ADDENDUM

Date Issued:	Jan 7, 2025
Project:	Intermountain Health RAD Room Remodel 3741 West 12600 South Riverton, Utah 84065
Addendum Number:	1

Riverton Hospital Radiology Room Remodel

Subject: Intermountain Riverton Hospital Radiation Room Remodel – Structural Evaluation

1 TYPICAL CONCRETE SLAB ON GRADE PROFILE AT TRENCH
NO SCALE

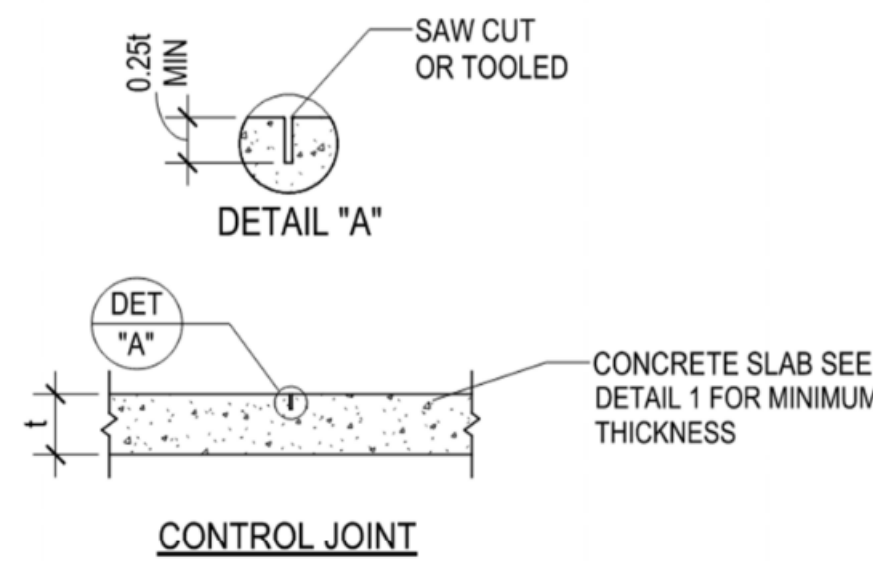
Trench fill for electrical, mechanical, or plumbing installations should follow Detail 1 and comply with specification sections 033000 and 312323.33. Conduits less than 3 inches in diameter may be backfilled with compacted granular fill or clean sand. Control joints in the new concrete should match existing joint locations or be spaced a maximum of 2 feet on center to minimize cracking.

Floor Plan
Level 1 -
Overall

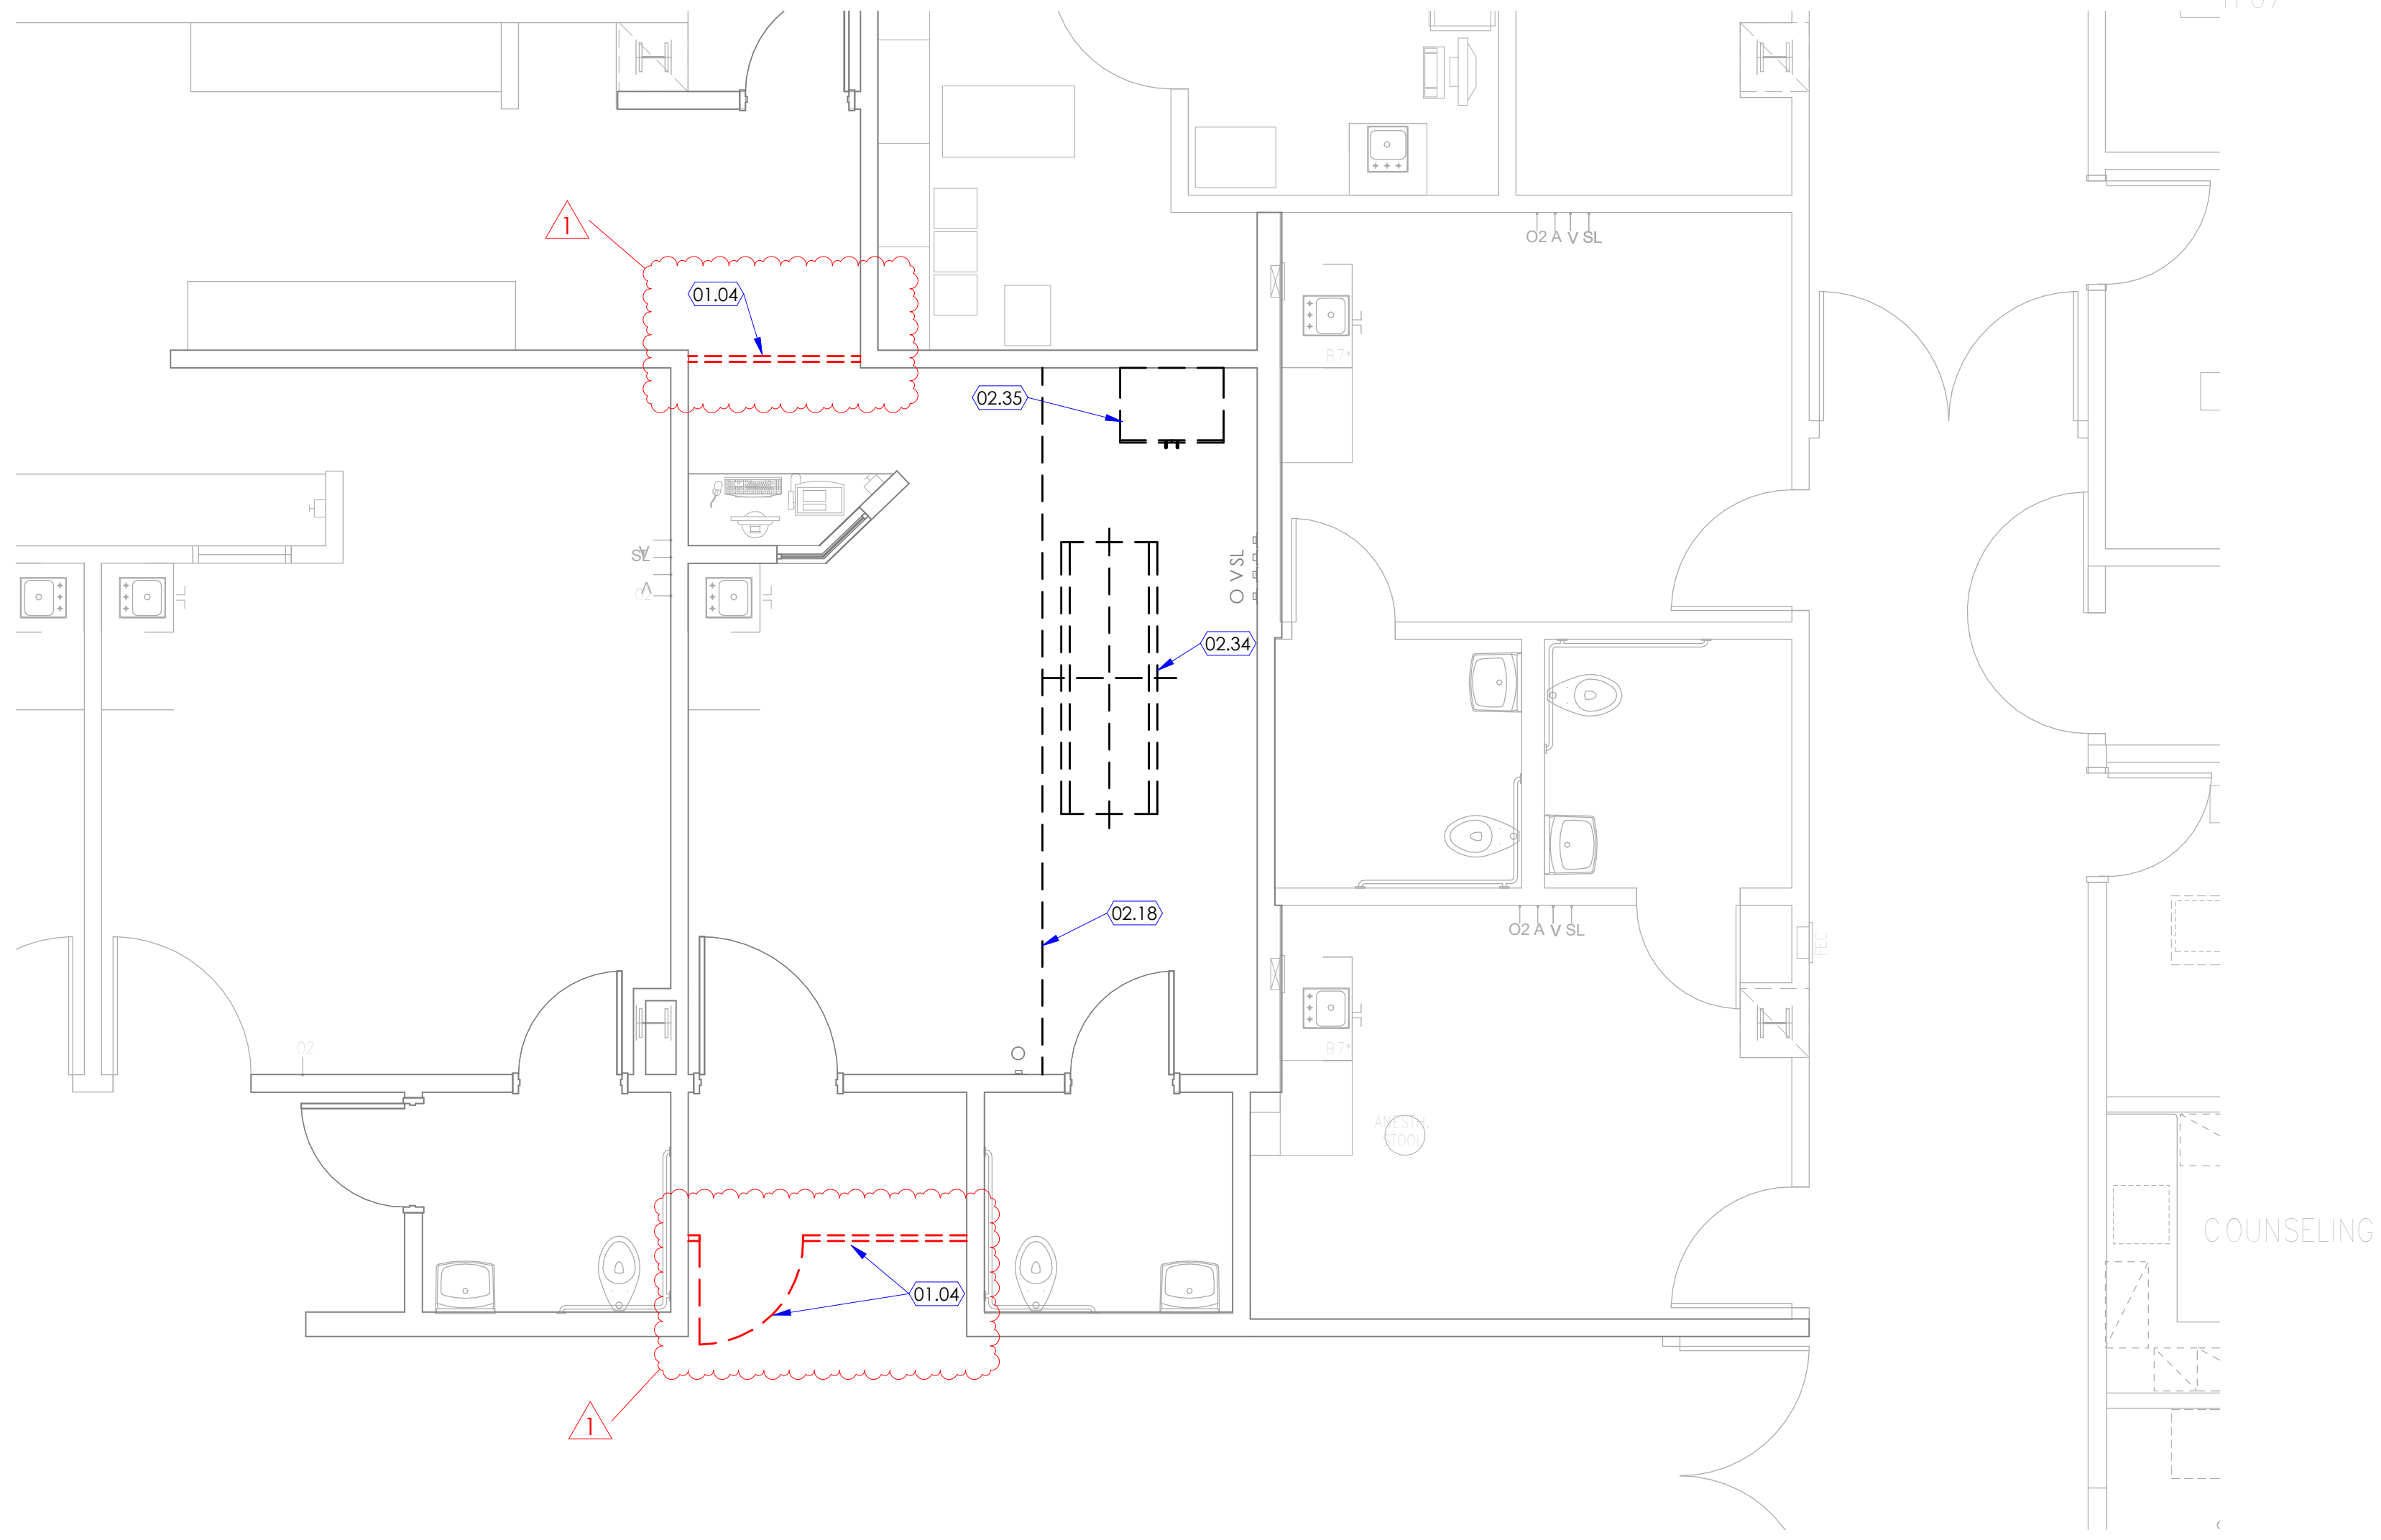
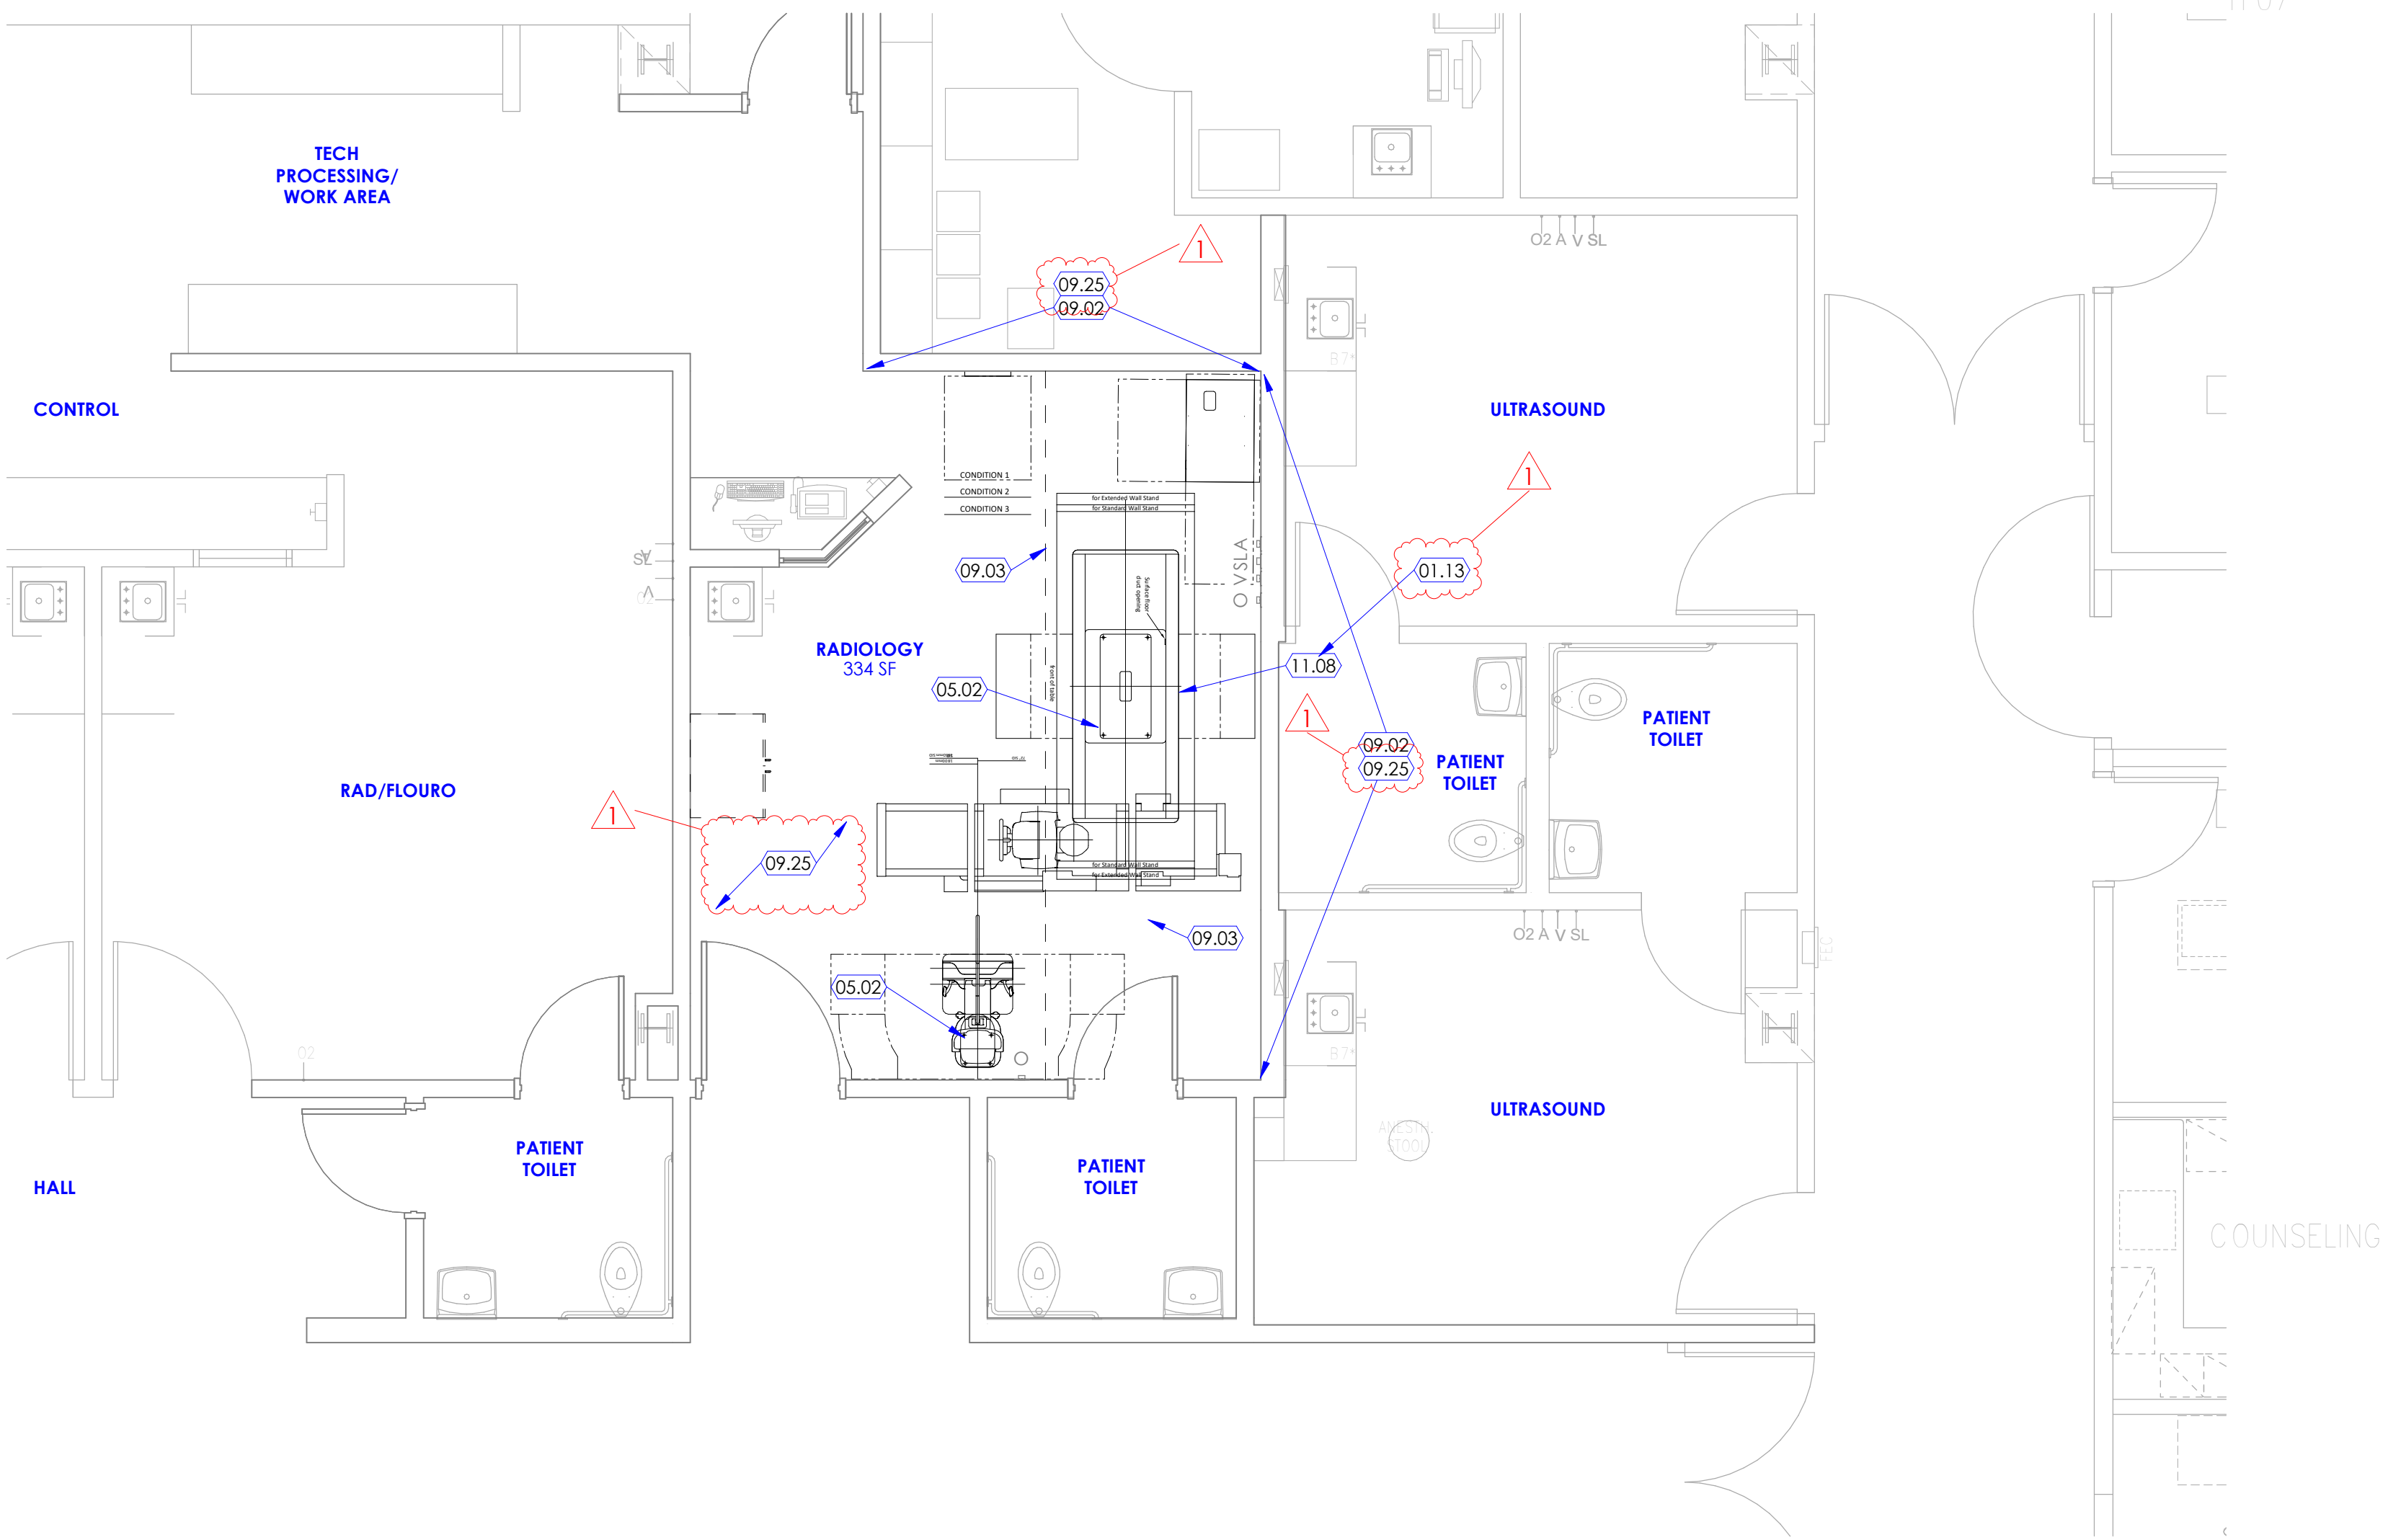
Sheet Number	Drawings
Architectural Drawings	
G001	Revise note for vendor equipment installation as indicated.
A110	Add sheet. Add keynote 01.15 as indicated.
A111	Revise ICRA barriers as indicated. Add keynote 01.13 and 09.25 as indicated.
A112	Add keynote 21.01 as indicated.
Structural Drawings	
S100	Add sheet.

01.15 LINE INDICATES CONTRACTOR ENTRANCE AND EQUIPMENT AND MATERIALS DELIVERY PATH. CONTRACTOR SHALL TAKE NECESSARY PRECAUTIONS TO AVOID DAMAGING EXISTING FINISHES ALONG THIS PATH. CONTRACTOR SHALL BE RESPONSIBLE FOR REPAIRING ANY DAMAGE ALONG THIS PATH AS A RESULT OF CONSTRUCTION ACTIVITIES OR MATERIALS AND EQUIPMENT DELIVERY. CONTRACTOR SHALL PROVIDE DUMPSTER WITH COVER. COORDINATE DUMPSTER LOCATION WITH OWNER.
